CONTRACT CHANGE ORDER NO. _____
SHEET ____ OF ____

| MARK | DATE | DESCRIPTIONS | BY | CH'D | CCO# |
|---|---|---|---|---|---|
| 1 | 02/04/11 | BIKEPATH STUD ISSUE | CC | MN | 186 |

SAN FRANCISCO OAKLAND BAY BRIDGE
EAST SPAN SEISMIC SAFETY PROJECT
SELF-ANCHORED SUSPENSION BRIDGE
(SUPERSTRUCTURE & TOWER)

# BIKEPATH DETAILS NO. 17

PARTIAL PLAN AT PP127 (See Note 4)
1:20

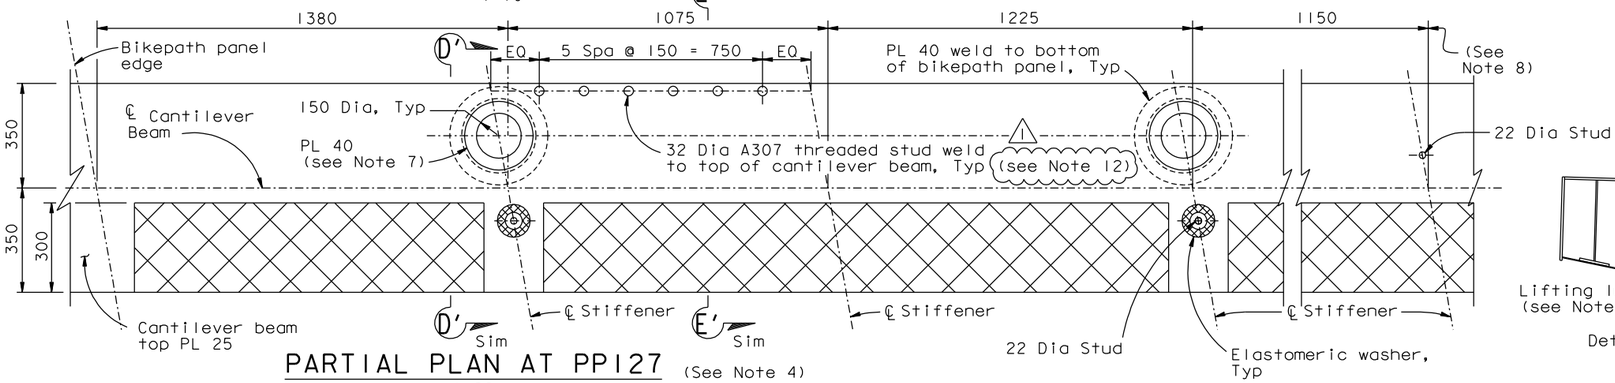
4. Provide tie down studs per " Bikepath Details No.4" sheet.
5. For stringer angle stiffeners at traveler rails see "Bikepath Details No.19" sheet.
6. For Details not shown, see "Bikepath Details No.15" and "Bikepath Details No.15A" sheets.

12. ASTM A108 Grade C1018, with mechanical properties conforming to that of Type B Studs in AWS D1.1 Table 7.1, may be used in lieu of ASTM A307.
